SCI-823-0.00
PID Nos. 19415, 77366, 79977

Value Engineering Study Report
Draft Stage 2 Design Phase

re: SCI-823-0.00, PID Nos. 19415, 77366 and 79977, Portsmouth Bypass
Harrison, Jefferson, Madison and Porter Townships, Scioto County
Value Engineering Study Report

SCI-823-10.31
 PID 79977

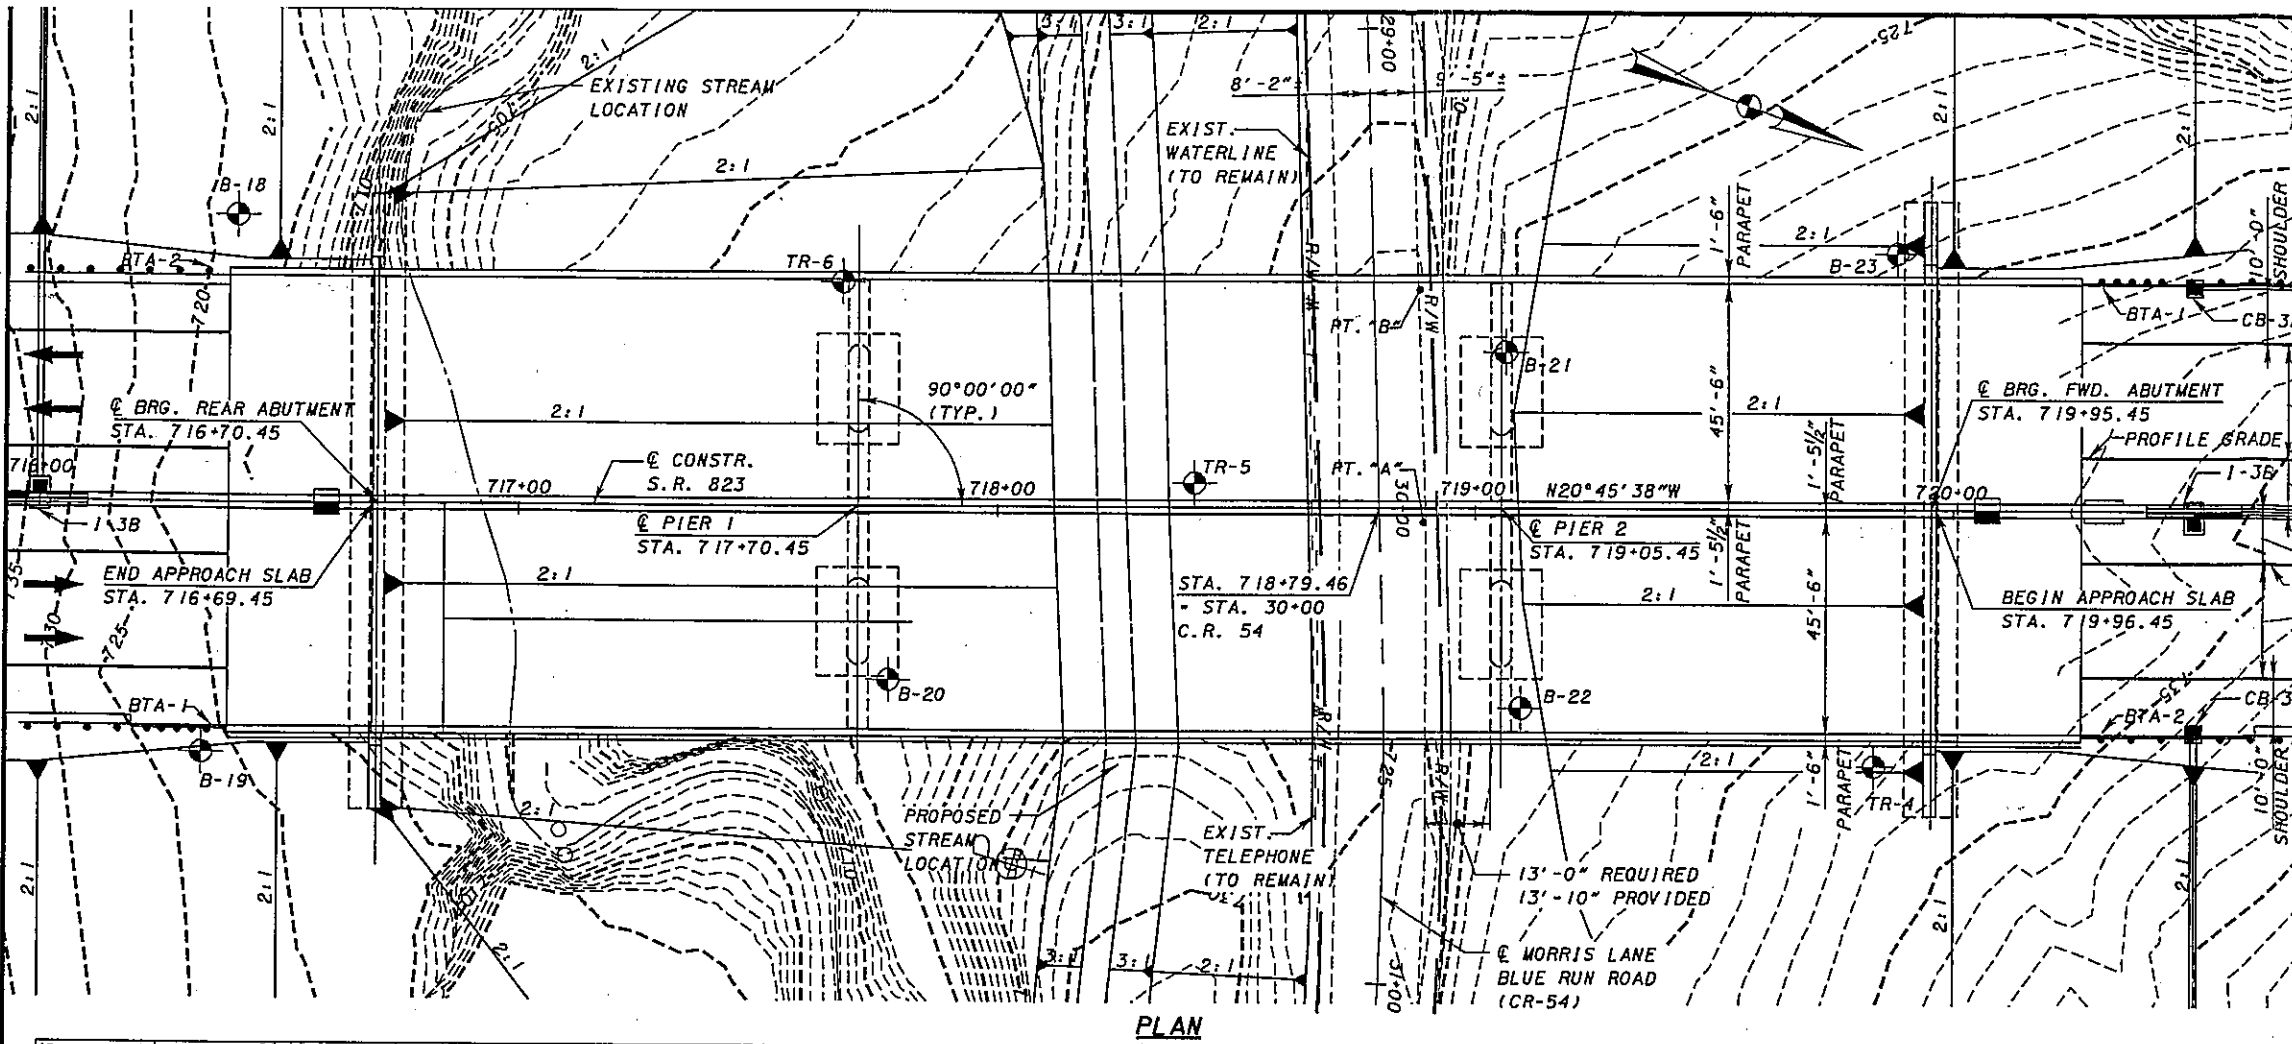
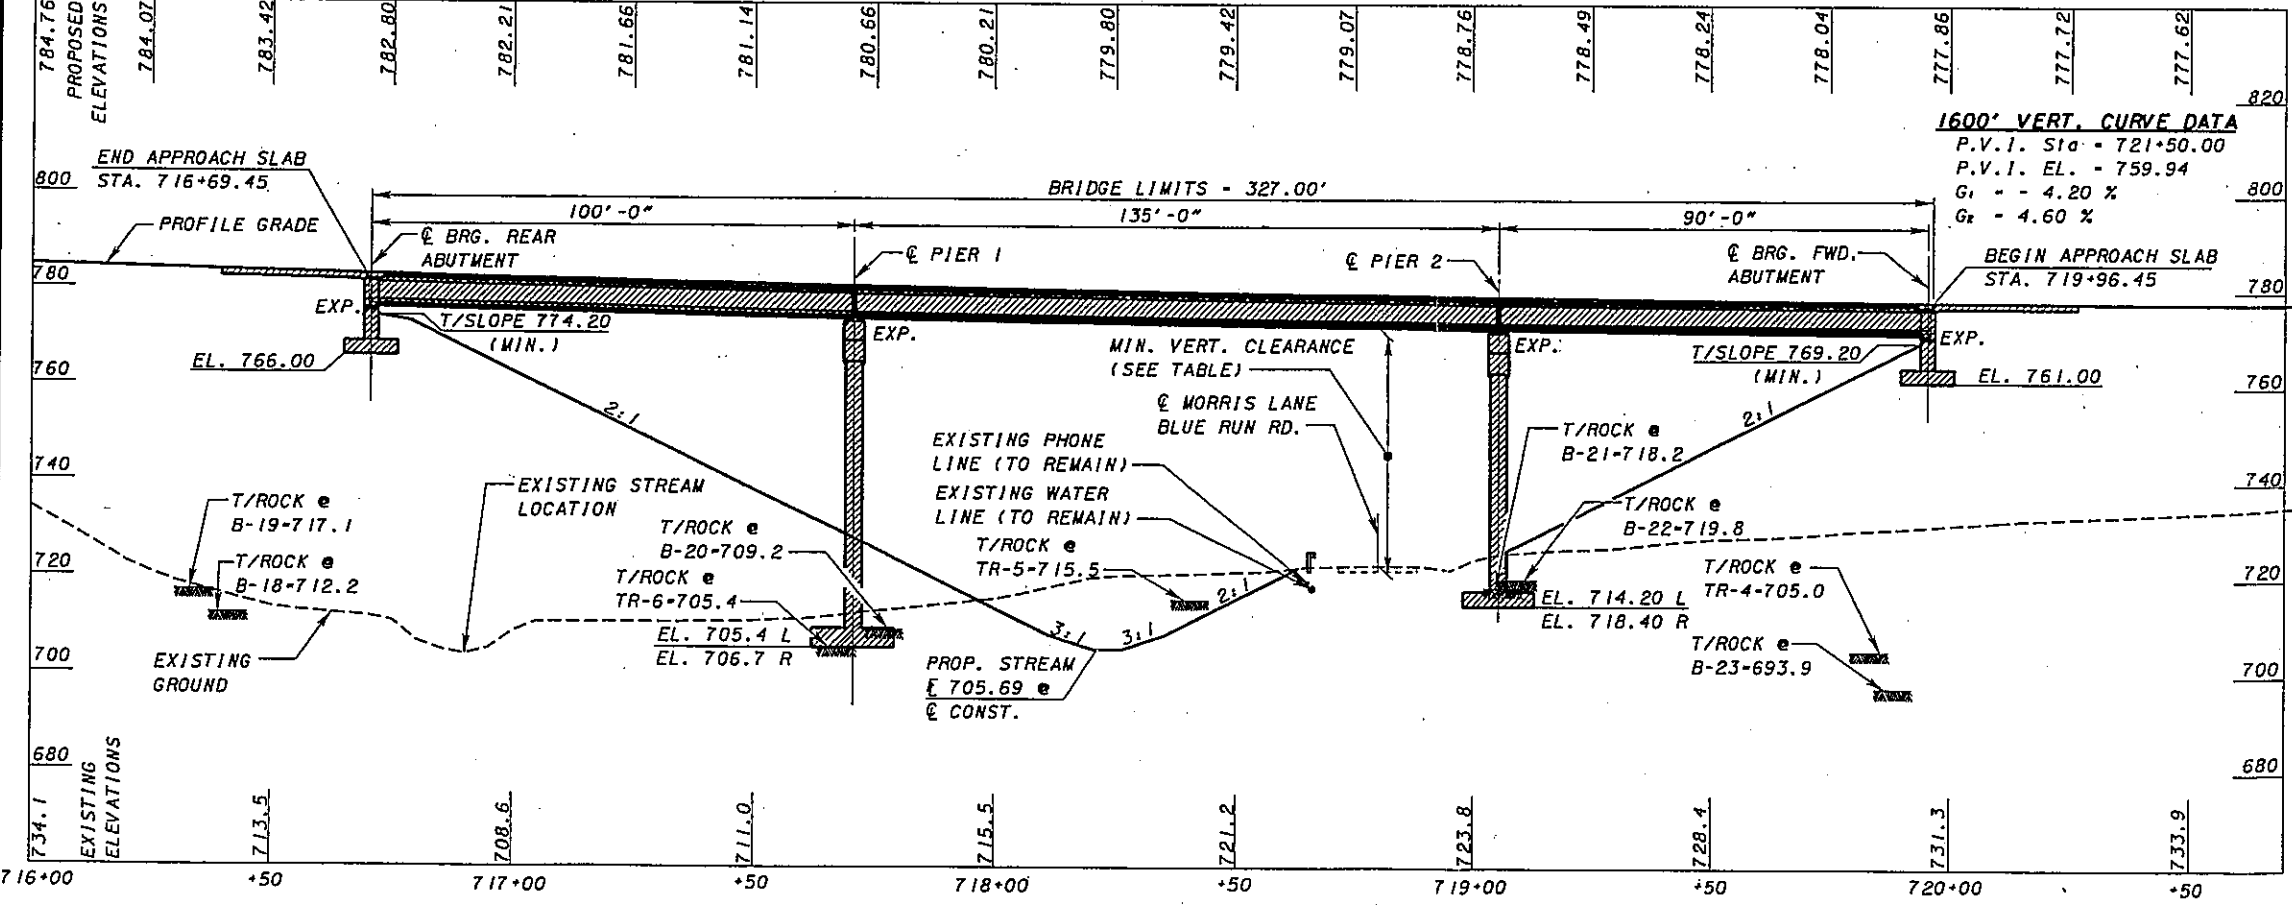
- SCI-823-1018 L&R – Site Plan
- SCI-823-1018 L&R – Pier Details
- SCI-823-1357 L&R – Site Plan
- SCI-823-1357 L&R – Pier Details

Similar change may apply to other bridges. Savings is approximately \$600,000 per bridge for the attached two example bridges.

- Revised SCI-823-1018 L&R – Site Plan
- Revised SCI-823-1018 L&R – Pier Details
- Revised SCI-823-1357 L&R – Site Plan
- Revised SCI-823-1357 L&R – Pier Details
